## TECHNICAL SERVICE BULLETIN

### Plastic Trim Around USB-C Ports On The First-Row Seat Back Is Loose

**26-2186**  
22 April 2026

<b>Ford</b> 2025 Expedition	Built on or before 10-Oct-2025
--------------------------------	--------------------------------

Figure 2

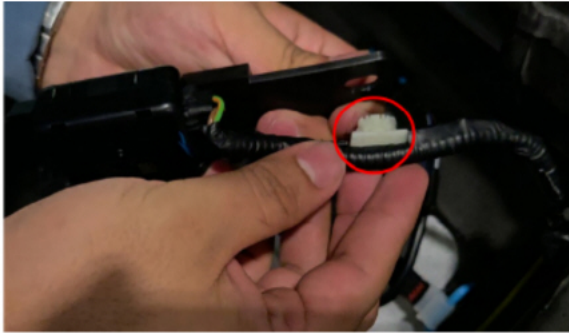
5. Release the harness retainer by pushing it out from behind the bracket (Figure 2).

Figure 3

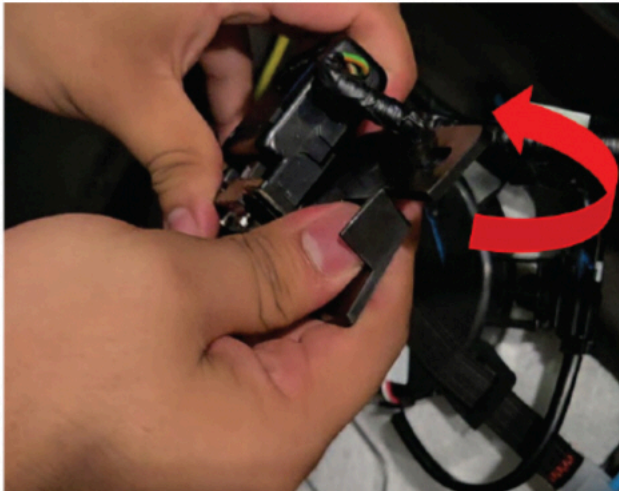
6. Detach the USB-C module from the bracket. (Figure 3)
